Intel[®] IXP42X Product Line of Network Processors and IXC1100 Control Plane Processor

Specification Update

October 2004

Document Number: [252702-006](#)

Replace datasheet Figure 25, “Intel Multiplexed Mode”, with the following two figures, “Intel® Multiplexed Read Mode”, and “Intel® Multiplexed Write Mode”.

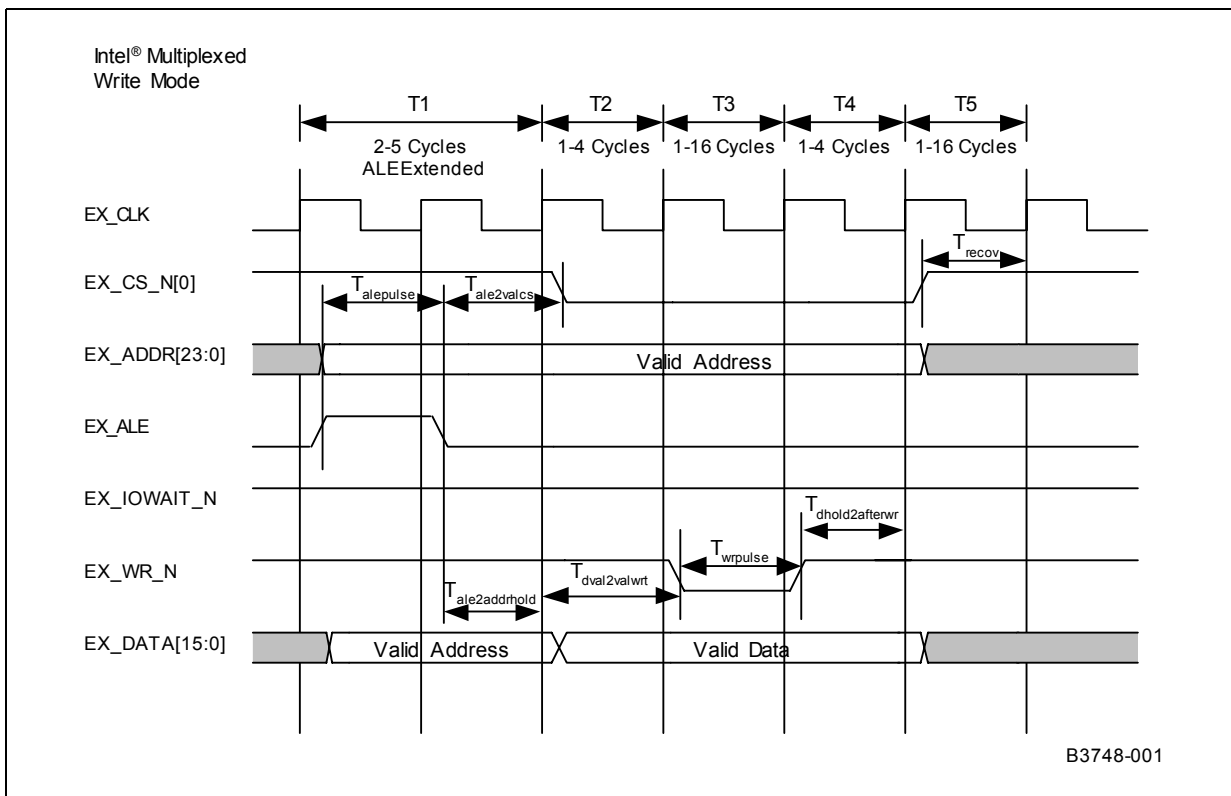
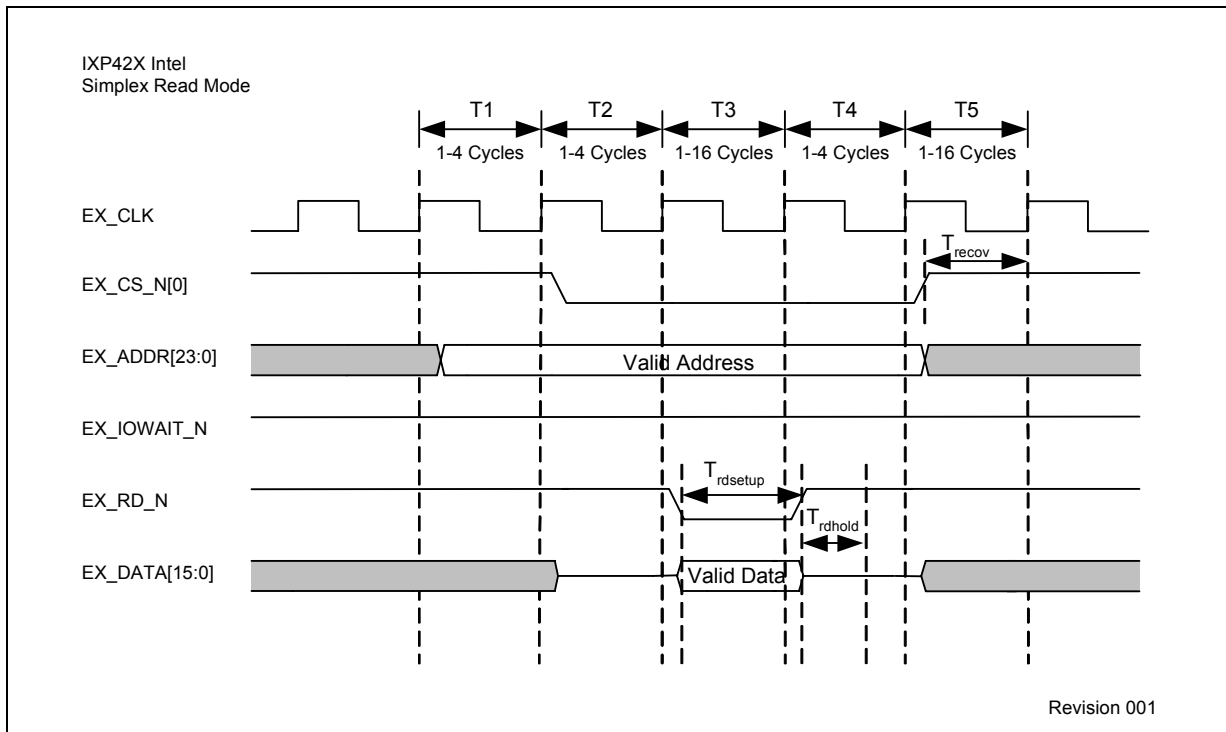
Issue: In the Intel® IXP42X Product Line of Network Processors and IXC1100 Control Plane Processor Datasheet, several Expansion Bus timing diagrams are incorrect. Figures 25–33 are affected.

Intel® Multiplexed Read Mode

Intel® Multiplexed Write Mode

HPI-8 Mode Write Accesses

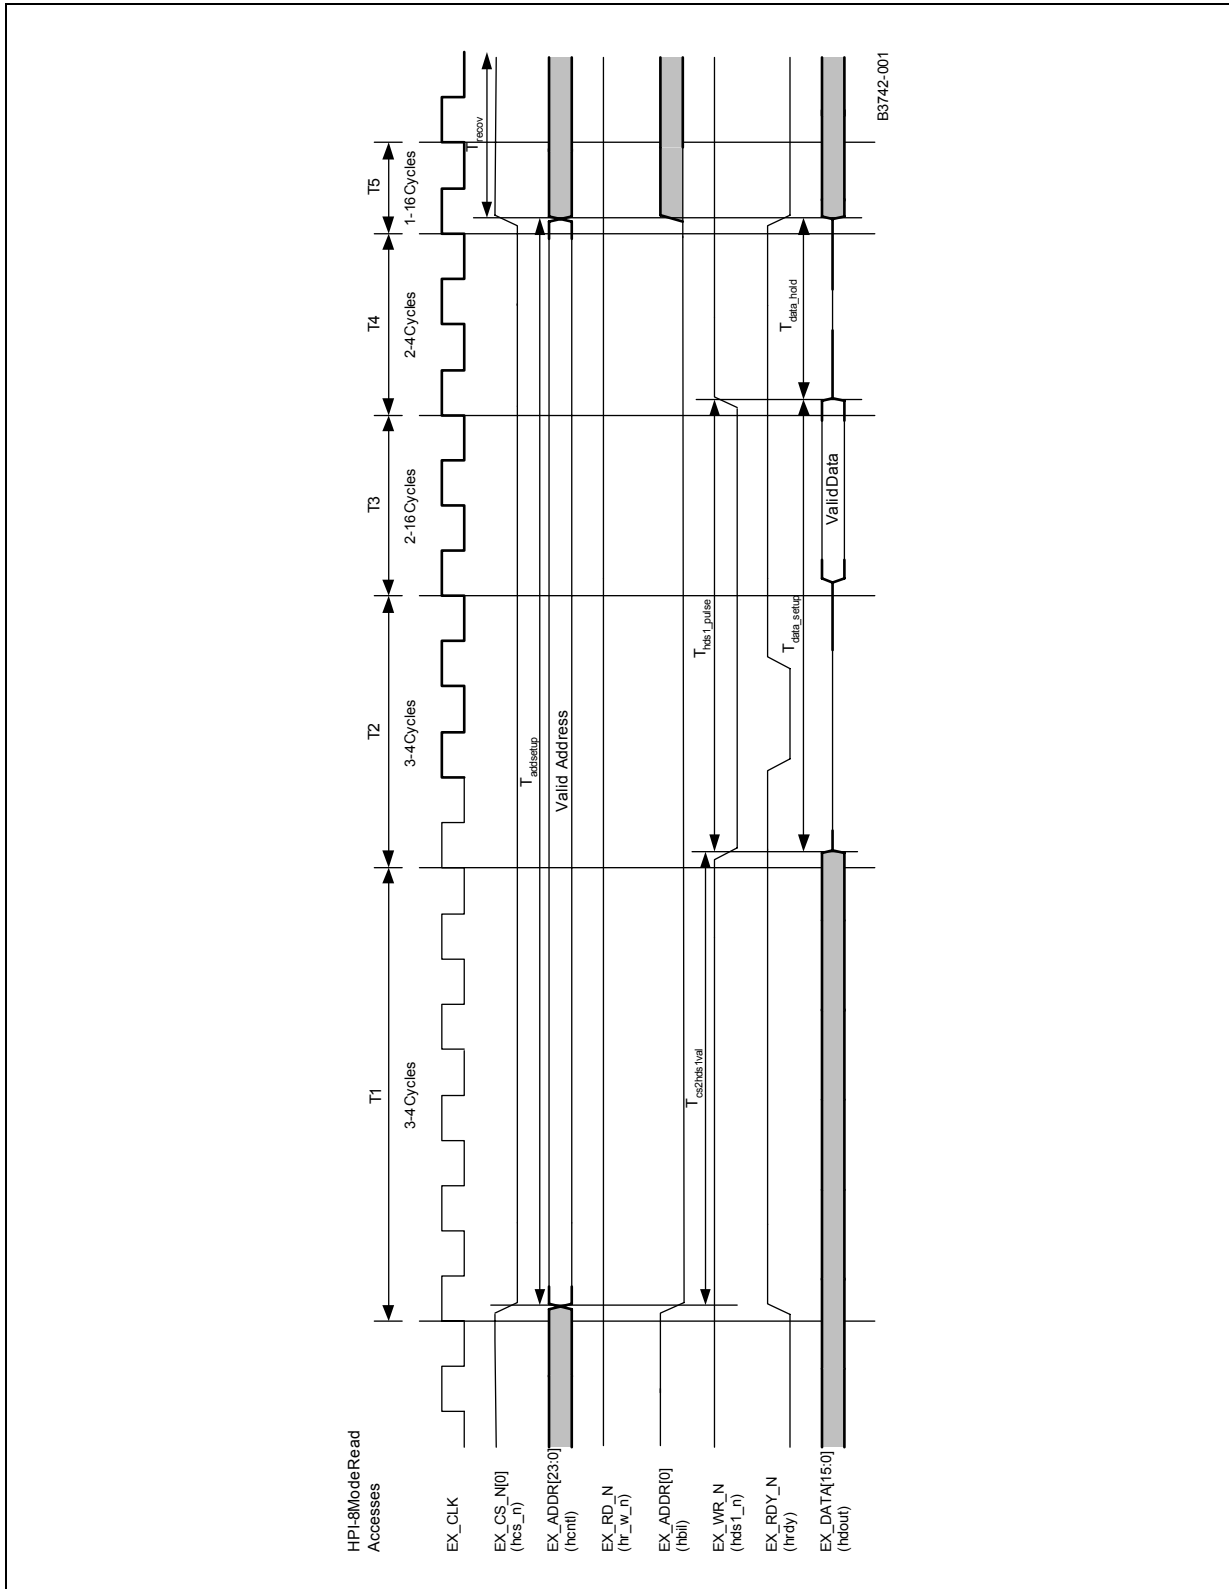
Replace datasheet Figure 29, “HPI-8 Mode Write Accesses”, with a new figure, “HPI-8 Mode Write Accesses”, which follows.

Replace datasheet Figure 30, “HPI-8 Mode Read Accesses”, with a new figure, “HPI-8 Mode Read Accesses”, which follows.

HPI-16 Multiplex Write Mode

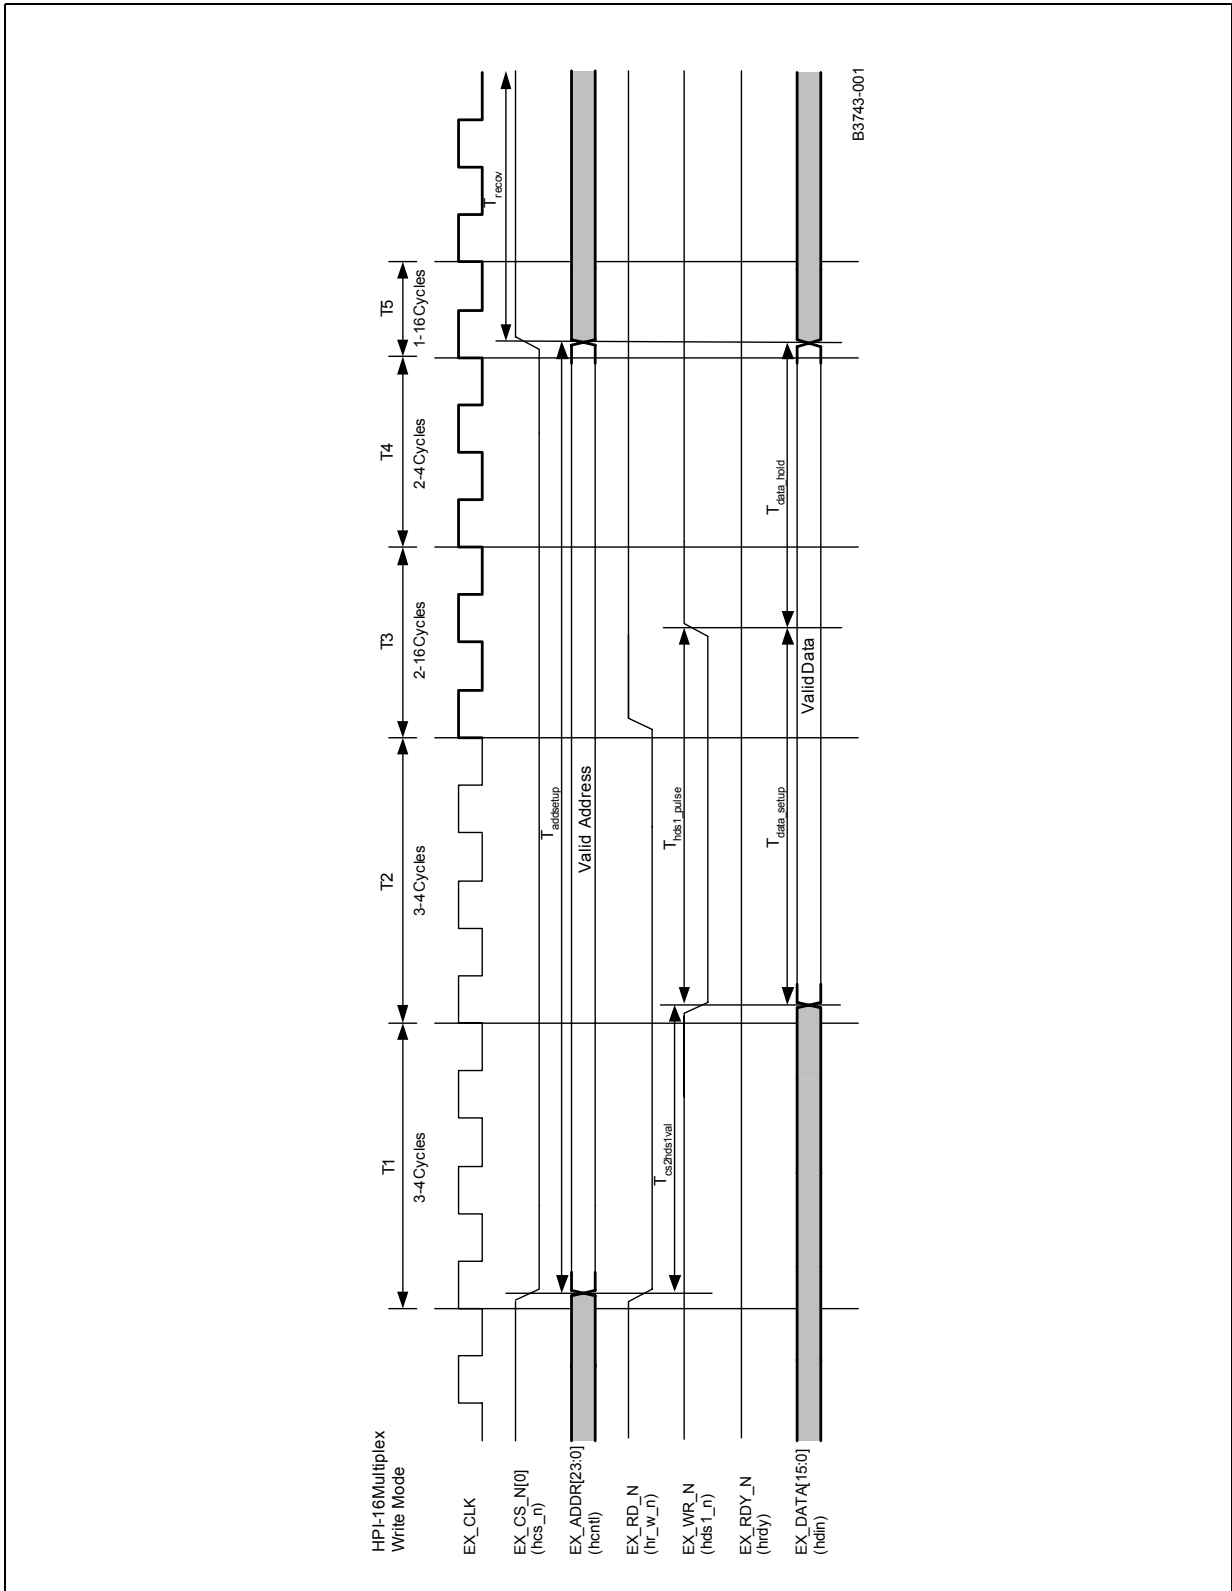
Replace datasheet Figure 31, “HPI-16 Multiplex Write Mode”, with a new figure, “HPI-16 Multiplex Write Mode”, which follows.

HPI-16 Multiplex Read Mode

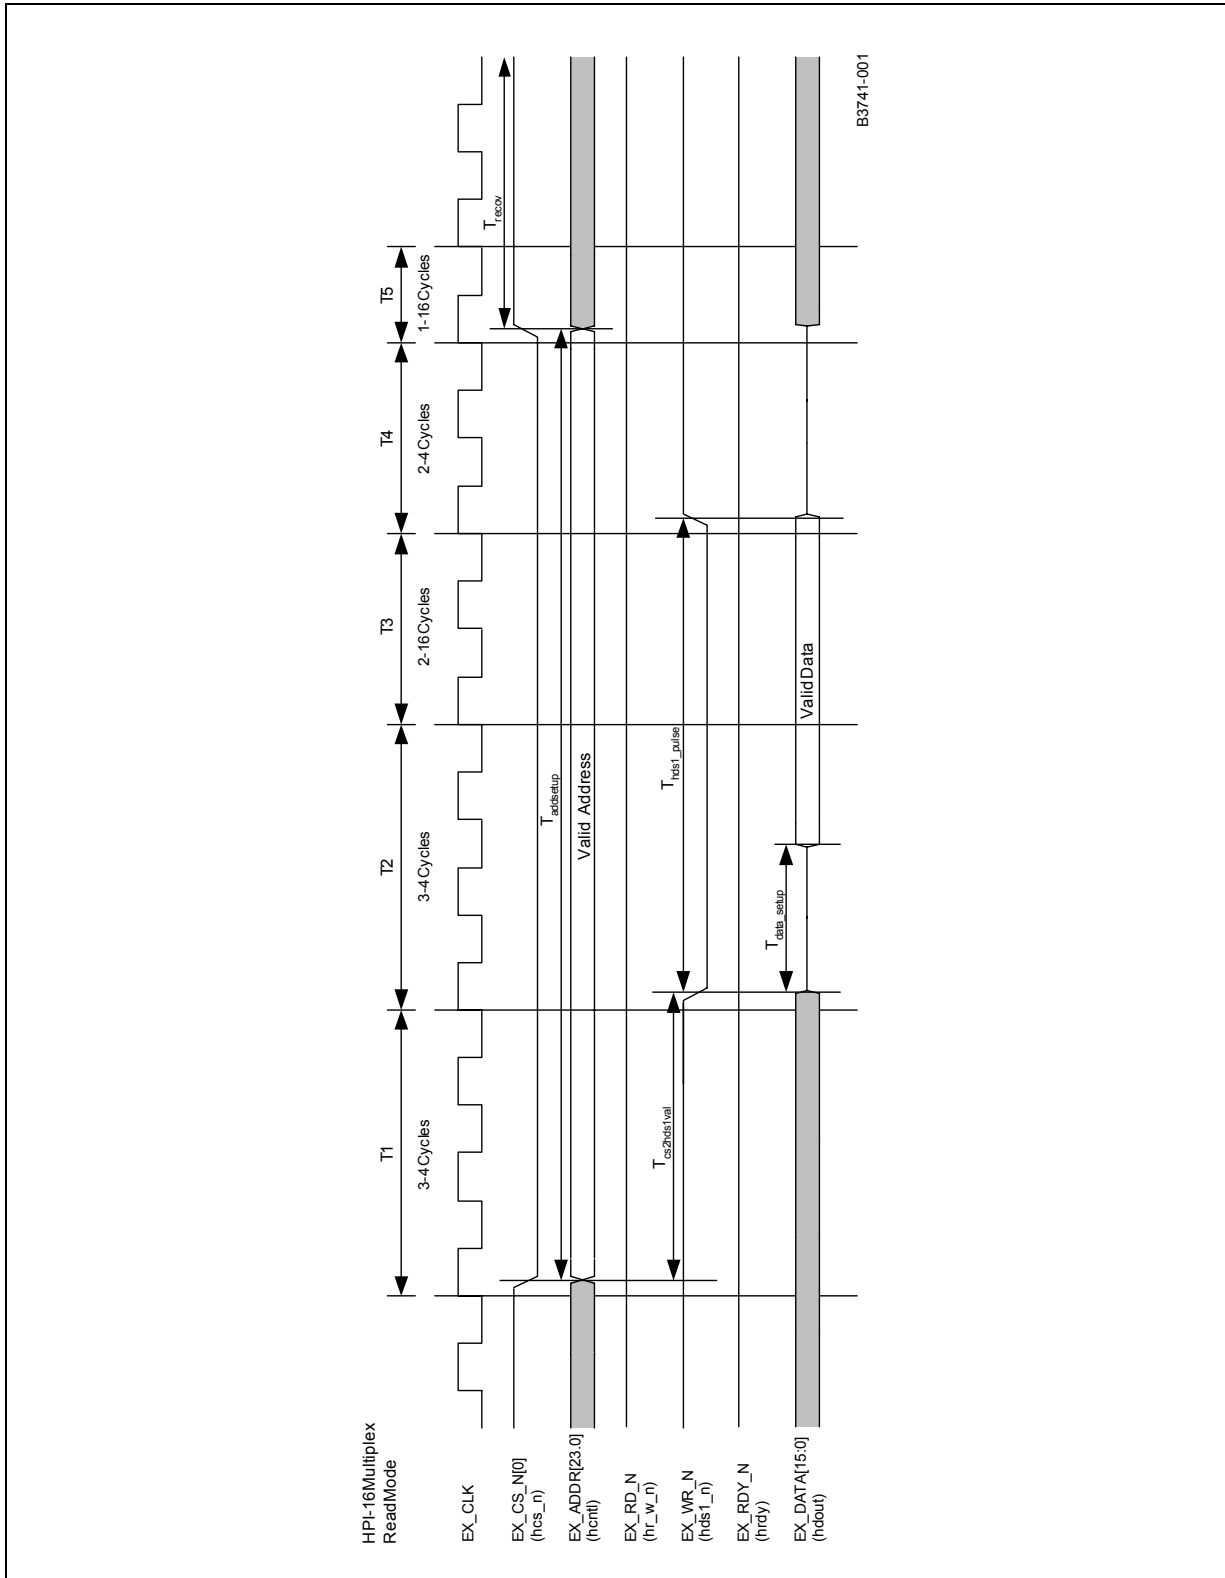
Replace datasheet Figure 32, “HPI-16 Multiplex Read Mode”, with a new figure, “HPI-16 Multiplex Read Mode”, which follows.

HPI-16 Simplex Read Mode

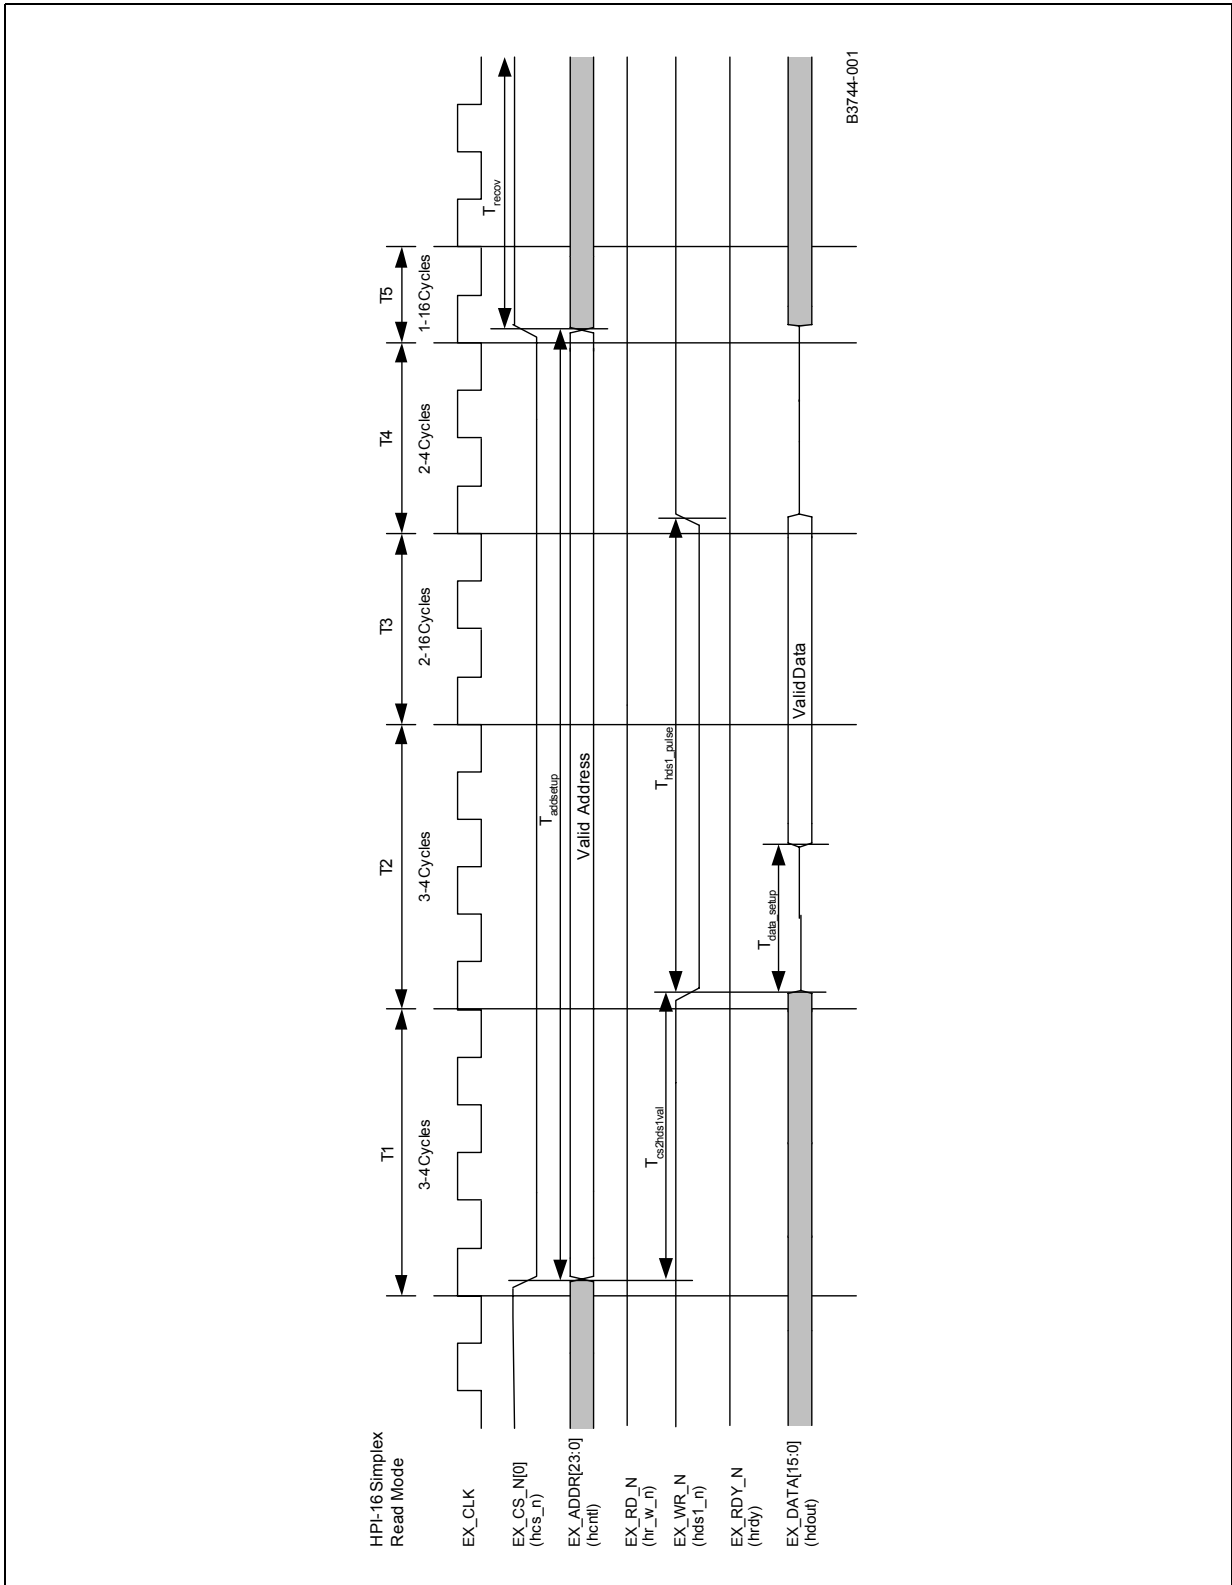
Replace datasheet Figure 33, “HPI-16 Simplex Read Mode”, with a new figure, “HPI-16 Simplex Read Mode”, which follows.
